WILLIAMSON COUNTY, TEXAS

CHANGE ORDER NUMBER: 6

Project:	<u>Great Oaks Dr. Improvements</u>
Roadway:	<u>Great Oaks Dr. @ Brushy Creek</u>
CSJ Number:	<u>T4327</u>

**Great Oaks Drive Improvements
Williamson County Project No. T4327**

GREAT OAKS DR AT BRUSHY CREEK RD
 RETAINING WALL LAYOUT
 WALL RW-1A

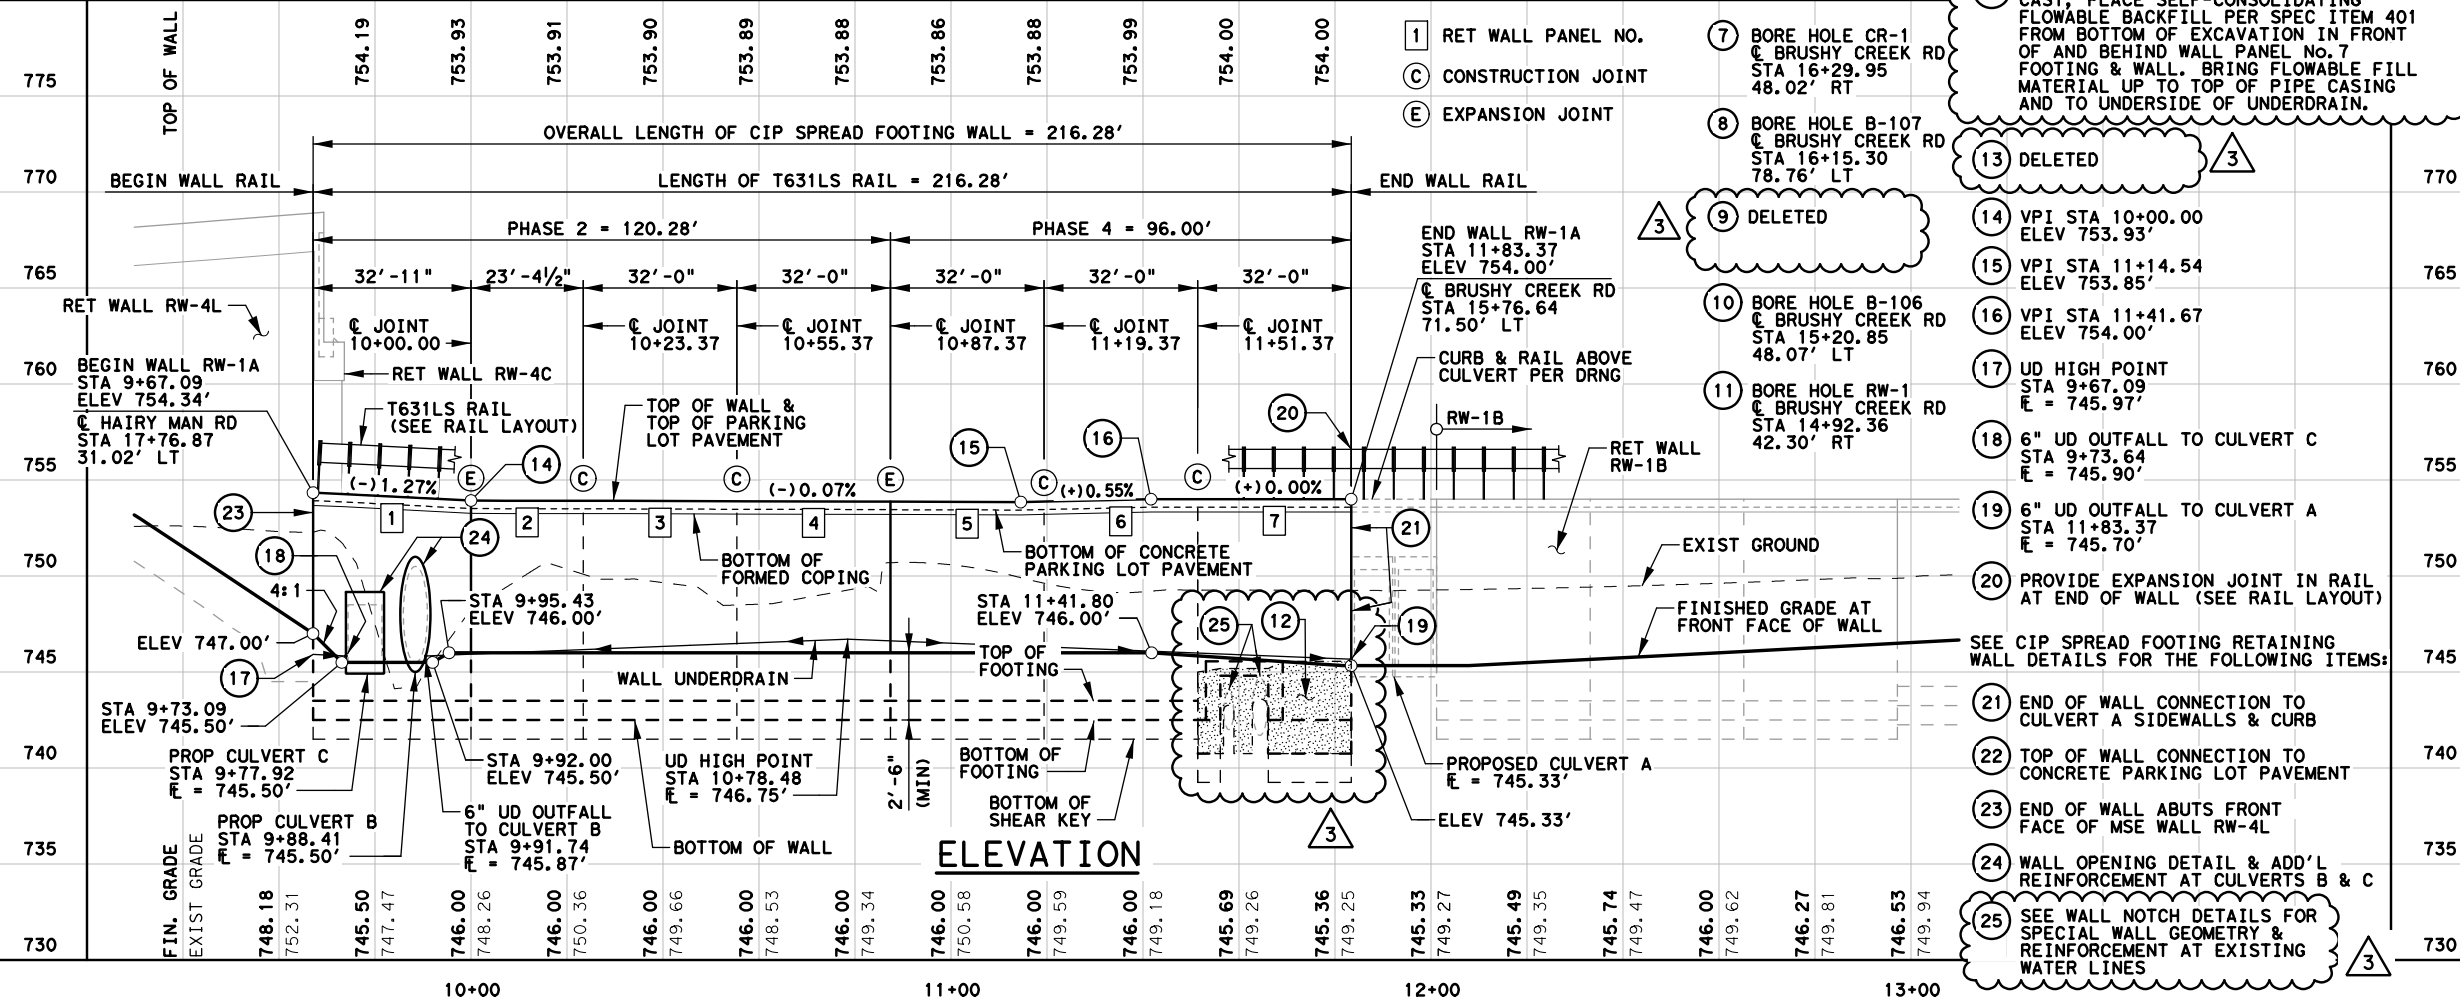
REV-3 CONSISTS OF MODIFIED DETAILS FOR CIP RETAINING WALL RW-1A, WALL PANEL NO. 7.

- 11 BORE HOLE RW-1 BRUSHY CREEK RD STA 14+92.36 42.30' RT
- 12 AFTER FOOTING & WALL HAVE BEEN CAST, PLACE SELF-CONSOLIDATING FLOWABLE BACKFILL PER SPEC ITEM 401 FROM BOTTOM OF EXCAVATION IN FRONT OF AND BEHIND WALL PANEL NO. 7 FOOTING & WALL. BRING FLOWABLE FILL MATERIAL UP TO TOP OF PIPE CASING AND TO UNDERSIDE OF UNDERDRAIN.

- 24 WALL OPENING DETAIL & ADD'L REINFORCEMENT AT CULVERTS B & C
- 25 SEE WALL NOTCH DETAILS FOR SPECIAL WALL GEOMETRY & REINFORCEMENT AT EXISTING WATER LINES

WALL PANEL NO. 7 AT EXISTING WATER LINES

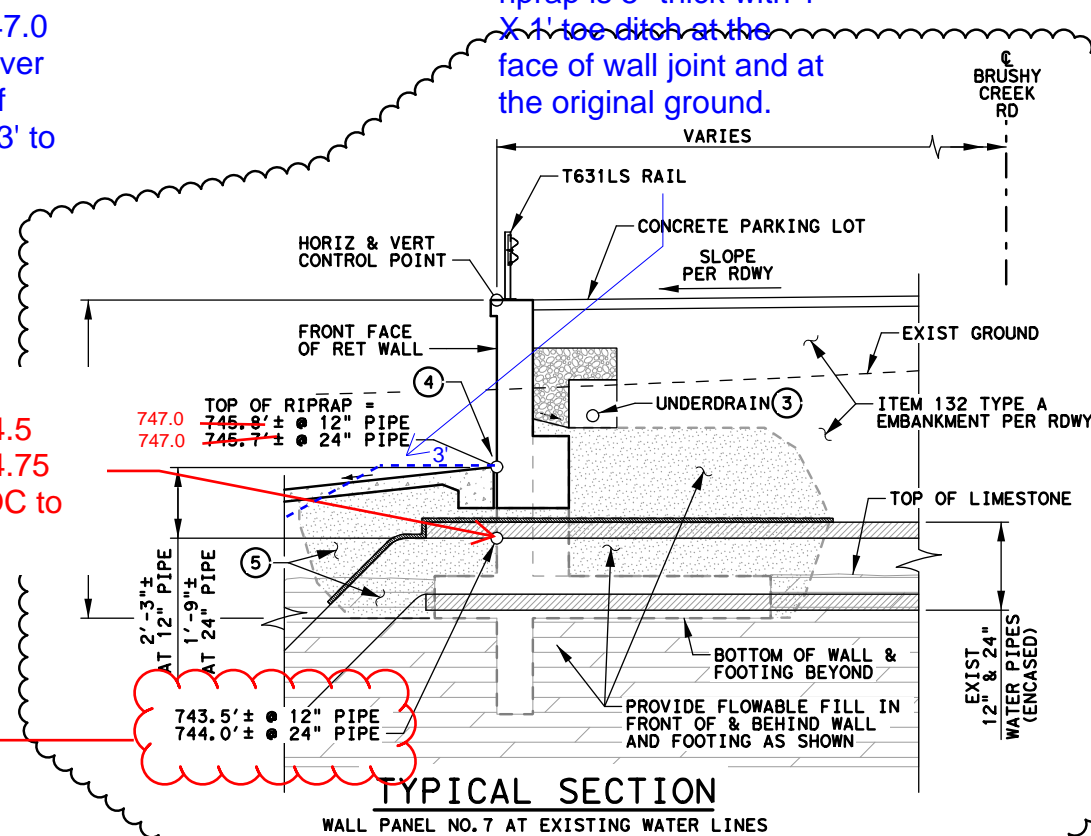
The proposed 747.0 elevation gives over 2' cover on top of casing and over 3' to top of pipe -- (flowable fill + concrete riprap)

If elevations are top of pipe top 24" casing for 12" = 744.5 top 42" casing for 24" = 744.75 This means only 1' from TOC to top of RR at 42" casing

confirm whether these elevations are top of pipe (as they appear to be drawn) or top of casing

These elevations are top of pipe

RETAINING WALL DETAILS
WALL RW1-A PANEL NO. 7
WALL & FOOTING DETAILS
AT EXISTING WATER PIPE

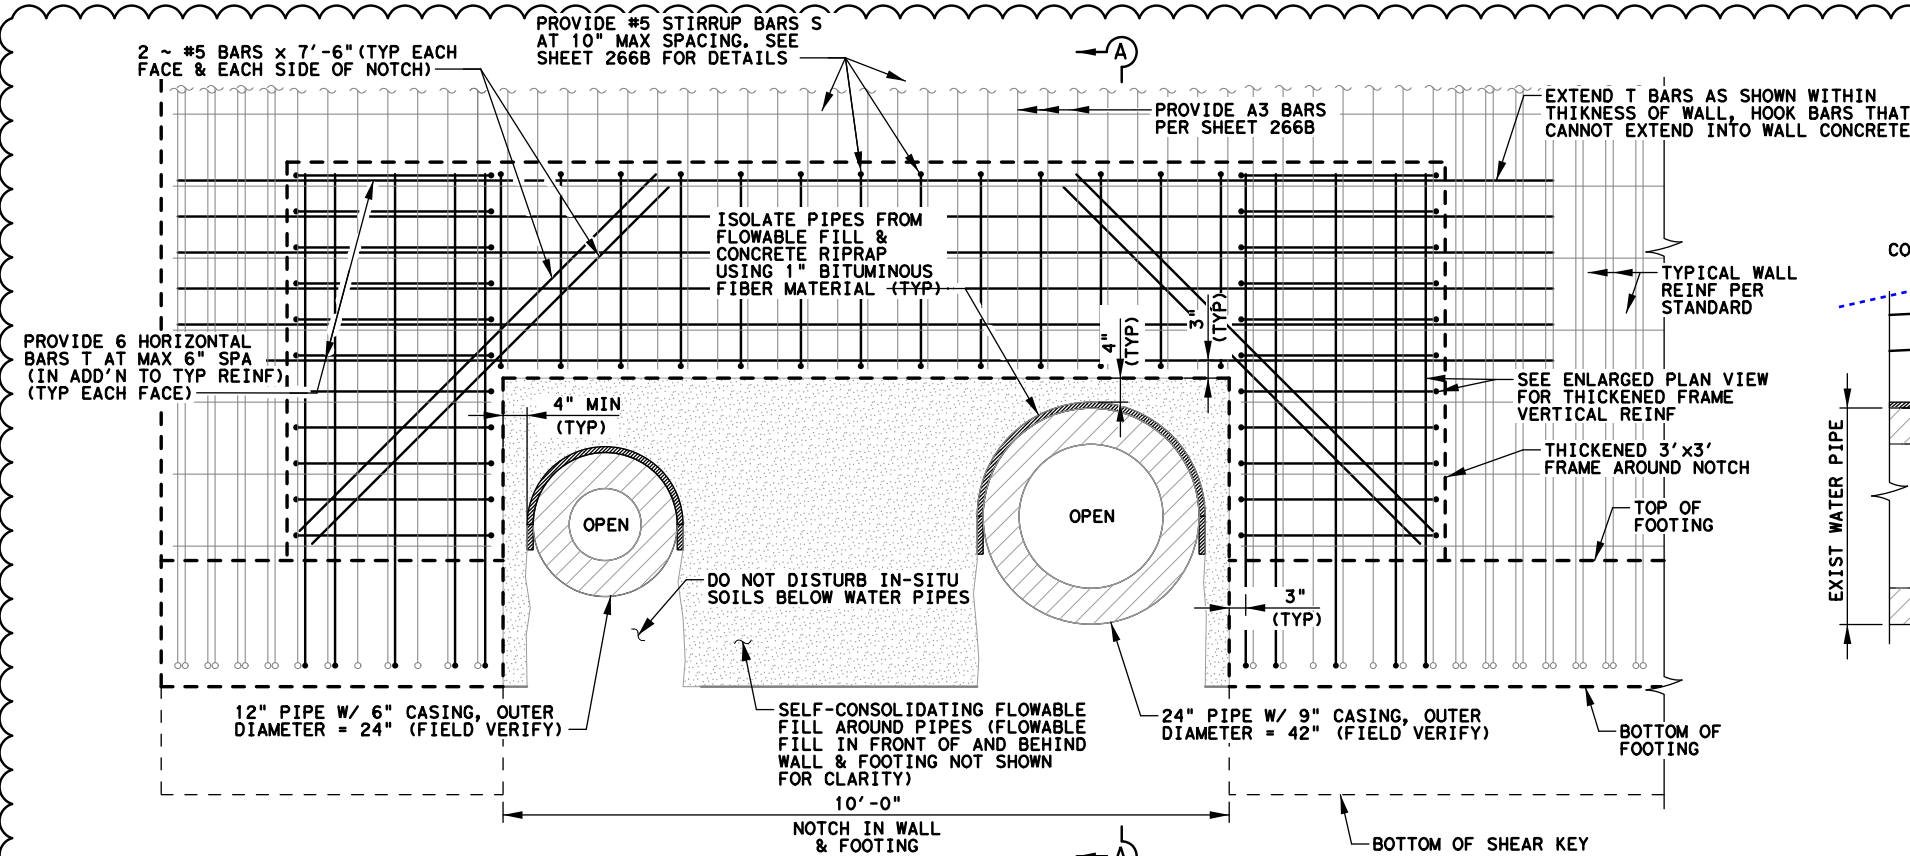
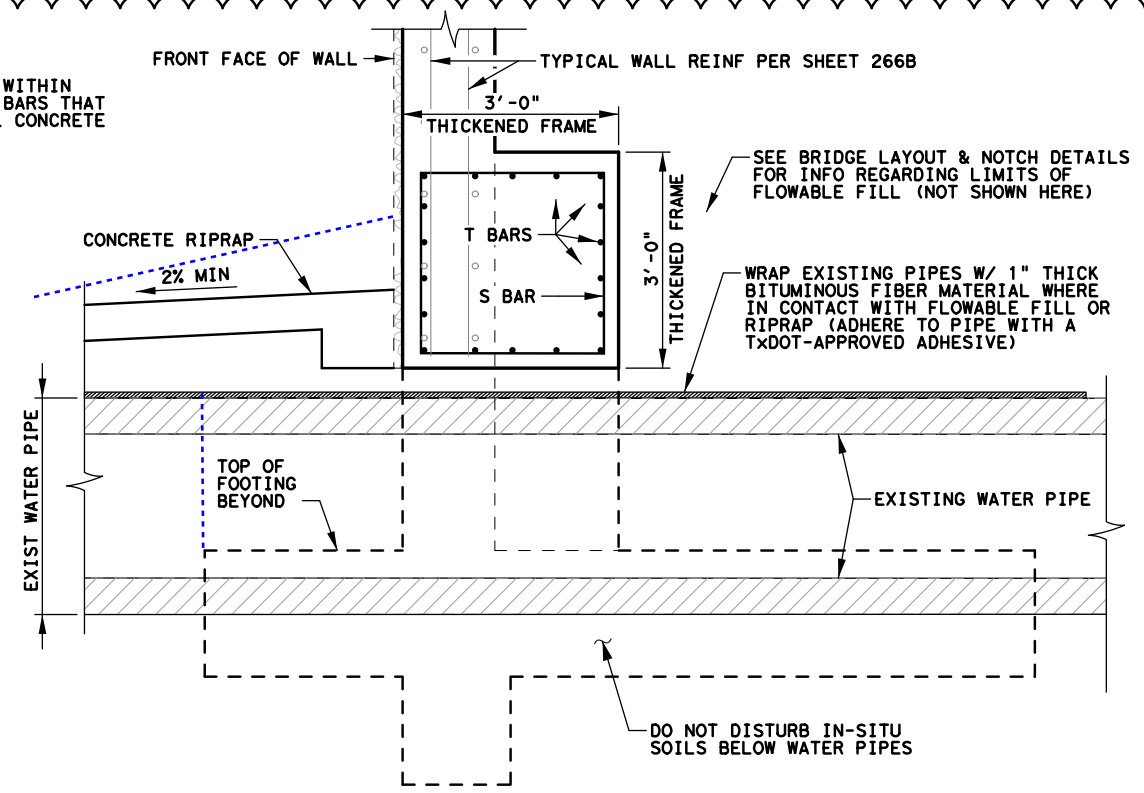
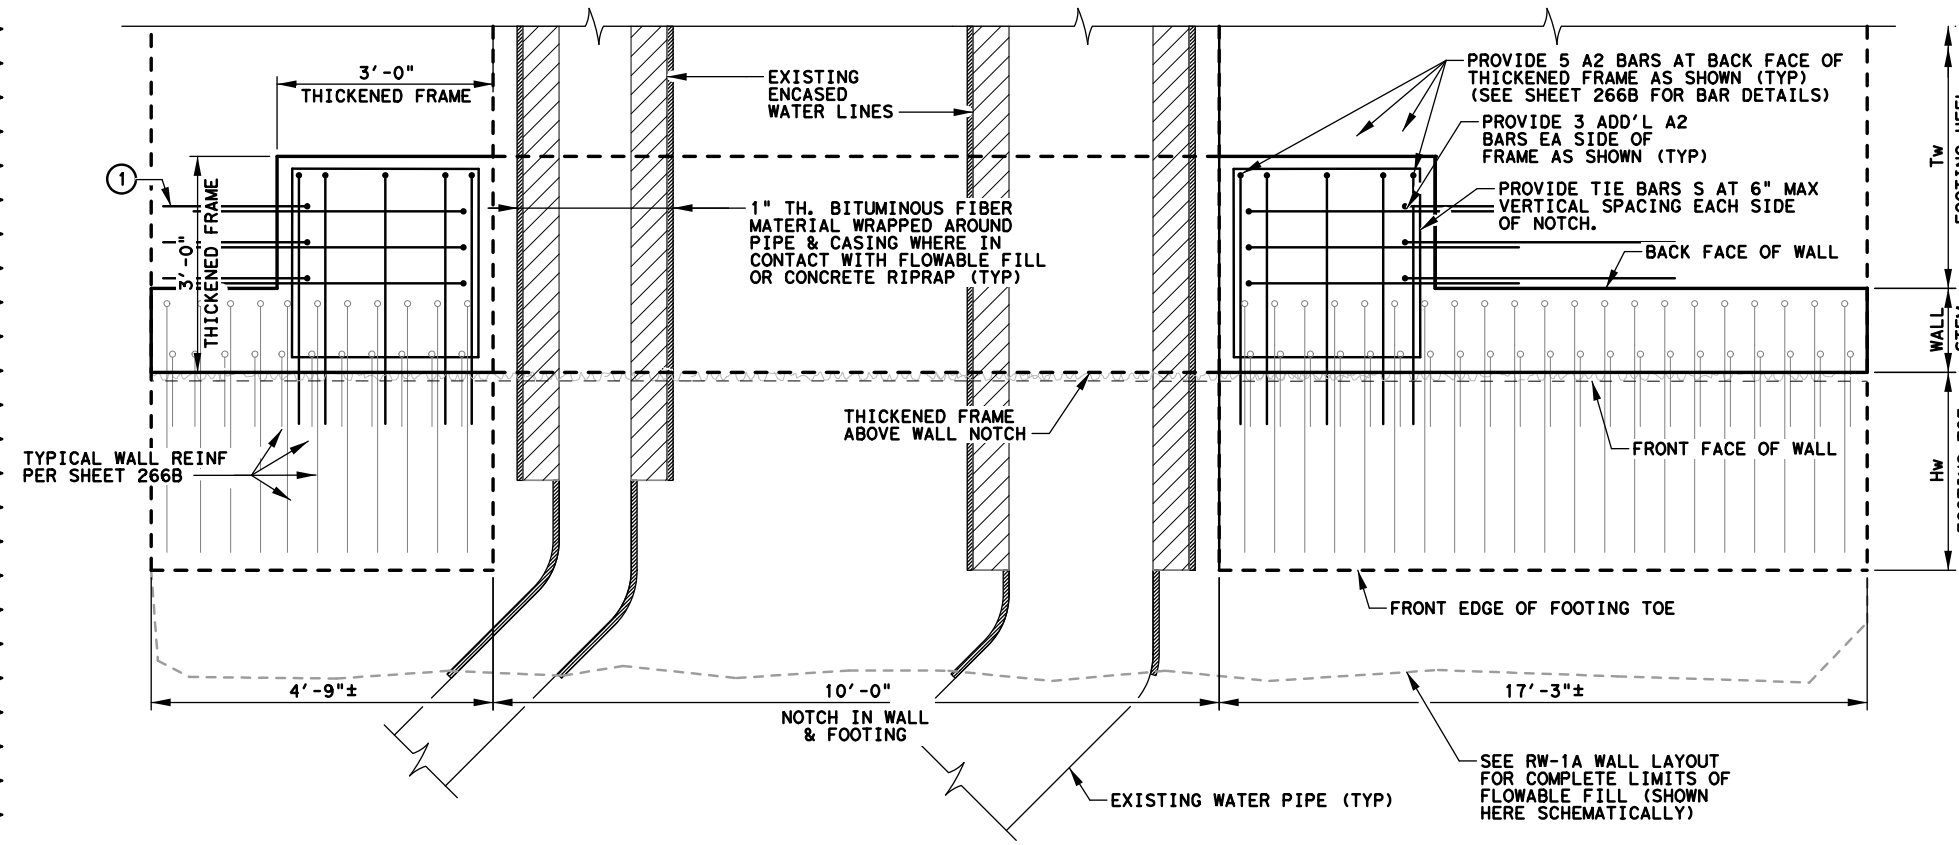
① REDUCE LENGTH OF A2 LEG LENGTH AS REQUIRED TO MAINTAIN 3" END CLEARANCE

CONTRACTOR SHALL TAKE CARE TO AVOID DAMAGING EXISTING WATER PIPES DURING WALL CONSTRUCTION.
 NOTIFY ENGINEER IF CONDITIONS DIFFER FROM THOSE SHOWN HERE.

③ REV-3 CONSISTS OF MODIFIED DETAILS FOR CIP RETAINING WALL RW-1A, WALL PANEL NO. 7.

GREAT OAKS DR AT BRUSHY CREEK RD
RETAINING WALL DETAILS
WALL RW1-A PANEL NO. 7
WALL & FOOTING
DETAILS

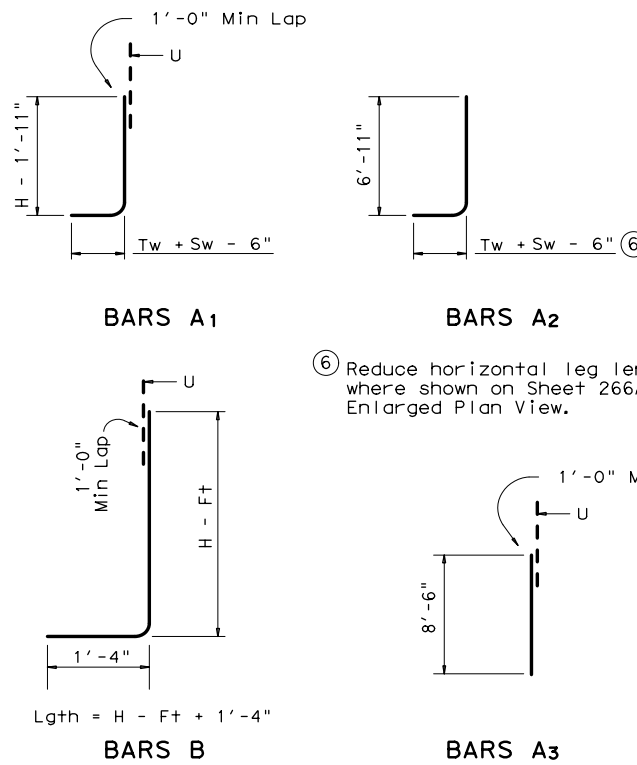
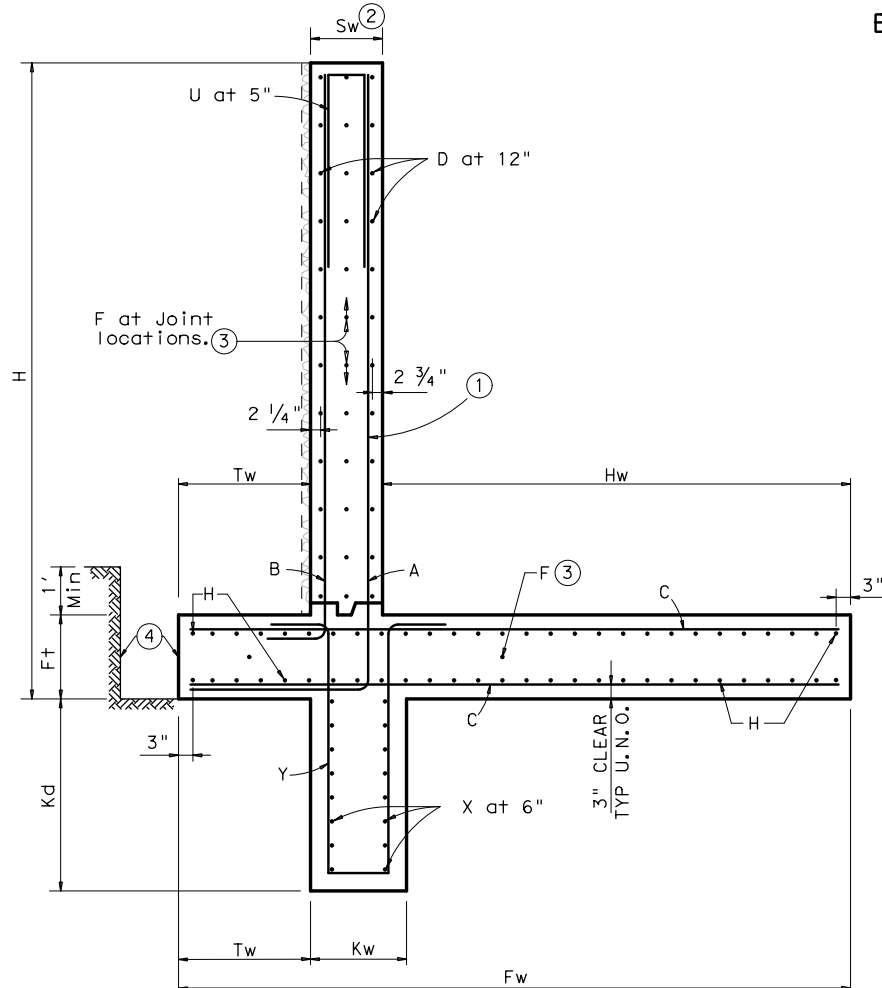
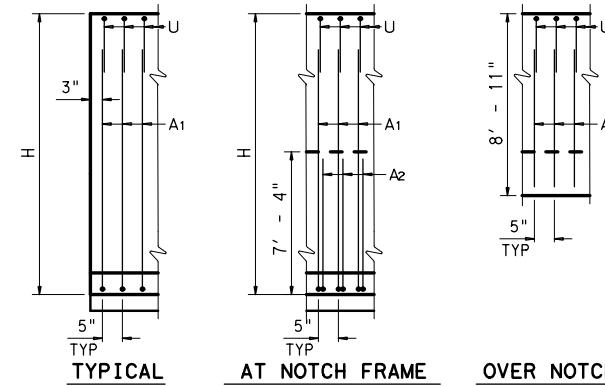
- Space Vertical S Stirrups at 10" c-c, and space Horizontal S Ties at 6" c-c. See Notch Details for additional information.

- Reduce horizontal leg length where shown on Sheet 266A Enlarged Plan View.

REV-1 CONSISTS OF MODIFIED DETAILS FOR CIP RETAINING WALL RW-1A, WALL PANEL NO. 7.
